Access Compliance Report Public Rights-of-Way (Pedestrian Signals)

Main Street: MOUNTAIN_VIEW_AVE Cross Street: KELLOGG_DR Location: W

ADA ID: SGAT210922124846 Signal Type: One Push Button-Non APS Overall Compliance: No Severity Scores: BTN 1: 35 BTN 2: N/A No BTN: N/A

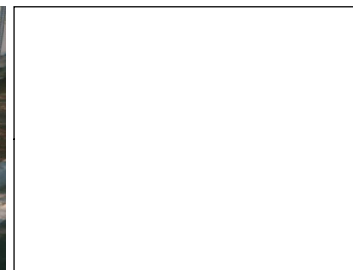
Yes B 1 Closed Fist Operation?		Yes	N/A	B 2 Closed Fist Operation?	N/A
Yes B 1 Diameter (in)		2.25	N/A	B 2 Diameter (in)	N/A
N/A B 1 Crossing Direction		NE	N/A	B 2 Crossing Direction	N/A
No B 1 DistanceTo XWalk (in)		72	N/A	B 2 DistanceTo XWalk (in)	N/A
Yes B 1 DistanceTo Curb (in)		35	N/A	B 2 DistanceTo Curb (in)	N/A
Parcel Identification Number		348-371-37			
Google Street View Link

Possible Solutions: Replace Signal Push Button With APS Button. Remove & Relocate Sign.
